# UNITED STATES PATENT AND TRADEMARK OFFICE

10/711,913

**Office Action Summary**

## DETAILED ACTION

FIG. 2

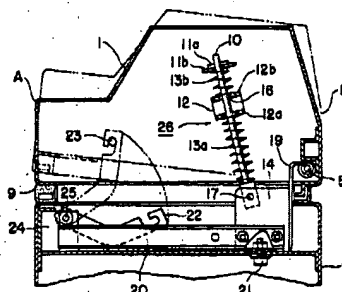
- {claim 1} A machine body (figure 2); a housing (figure 2); an upper body capable of being positioned at a range of angles relative to the housing (figure 2, reference 1); and a hinge (figure 2, reference 5) comprising a support shaft (figure 2, reference 10) connected to the upper body; and a support block (figure 2, reference 12) connected to the housing, the support block comprising a hole (figure 2, reference 16), and the support shaft passing through the hole (figure 2, reference 10) and capable of moving up and down along the hole (column 1, lines 43-47)

- {claim 2} wherein the support block is rotatably connected to the housing (figure 2, reference 12)
- {claim 3} wherein the hole is a cylindrical hole and the support shaft is a cylindrical shaft (figure 2, reference 10, 16)

- {claim 4} wherein the area of the cross section of the support shaft is constant over the length of the support shaft (figure 2, reference 10)
- {claim 7} wherein at least one section of the support shaft tightly fits the support block (figure 2, reference 10, 12)

- {claim 11} wherein the support shaft comprises a cylindrical shaft and wherein the hold comprises a cylindrical hole (figure 2)
- {claim 25} An apparatus (figure 2) comprising: means for coupling an upper body to a housing (figure 2), wherein the means for coupling comprises means for connecting a support shaft to the upper body (figure 2, reference 10), and means for supporting the support shaft in a sliding manner (through reference 12), and the means for supporting interfacing with the housing, wherein the upper body is capable of being positioned at any of a range of angles relative to the housing due to a frictional relationship defined by the means for supporting and the support shaft (figure 2)

- {claim 26} further comprising means for rotatably connecting the means for supporting to the housing (figure 2)
- {claim 27} wherein the means for supporting the support shaft comprises a support block that defines a straight hole and the support shaft comprises a straight shaft (figure 2)
- {claim 28} wherein means for supporting the support shaft comprises a support block that defines a straight cylindrical hole and the support shaft comprises a straight cylindrical shaft (figure 2)
- {claim 29} wherein the area of the cross section of the support shaft is constant over the length of the support shaft (figure 2)
- {claim 34} further comprising a joint axle by way of which the housing is rotatably attached to the upper body (figure 2, reference 17)

The following is an examiner's statement of reasons for allowance: The applicant's arguments with respect to the other claims are not persuasive, for the reasons stated below. However, with respect to claim 36, Miyasaka et al does not disclose that the support block is rotatable. Rather, it is pin 17, which is connected to support block 12 through shaft 10, that is rotatable.

The core of the applicant's argument is that "the Examiner has asserted that the 'support block 12' or Miyasaka is connected to the 'housing' (4). However, inspection of Figure 2 of Miyasaka readily reveals no such relationship is present. Moreover, Miyasaka confirms this understanding, stating that '...a balance mechanism guide 12 is secured to an inner surface of a side wall of the cover hood 1 [characterized as the 'upper body' by the Examiner] by welding or screws...'...Thus, the characterization advanced by the Examiner plainly contradicts the disclosure of Miyasaka."

The examiner understands the applicant's argument, but believes that the applicant has improperly narrowed the scope of the claimed invention by narrowly defining terms such as "housing" and "connected". The examiner reminds the applicant that the claims are given their broadest reasonable interpretation.

With regard to the housing, the examiner cited figure 2 without mentioning any reference numbers because it was believed to be self-evident what the housing was. However, since the applicant has expressed confusion, the examiner will attempt to clarify.

Given the broad use of the term housing (without any metes or bounds attached to the word as claimed), the housing does not need to be construed to be only represented by figure 4,

as the applicant has defined it. The examiner understands that the applicant is trying to distinguish a upper part of a machine body as "a upper body" and a lower part of a machine body as "a housing". However, the claims do not necessitate such a narrow reading. The examiner could broadly interpret housing as the entirety of figure 2 with the upper body 1 serving as a fragment of the housing. In such an interpretation where the upper block is part of (as opposed to separate from) the housing, the support block is indeed connected to the housing. The passage cited by the applicant (column 1, lines 44-46) supports this interpretation.

In fact, this is not the only reasonable interpretation of "housing". Even if housing is construed to be reference 4, as defined by the applicant, Miyasaka et al still broadly reads on the claims. The claim state a support block "connected" to the housing. The applicant believes that because support block 12 is physically attached to the cover hood 1, it cannot possibly be "connected" to reference 4. However, here again, the applicant is narrowing the definition of "connected." It could be broadly and reasonably construed that support block 12 is "connected" to reference 4 by way of attachment **through** shaft 10, pin 17, and the parts of pin 17 that attach to reference 4 (emphasis mine). The applicant is defining connected as physical attachment, but this definition is overly narrow. To be even more broad, the word could by defined in the context of "relationship", that is to say that the support block is related to reference 4, which is certainly true.
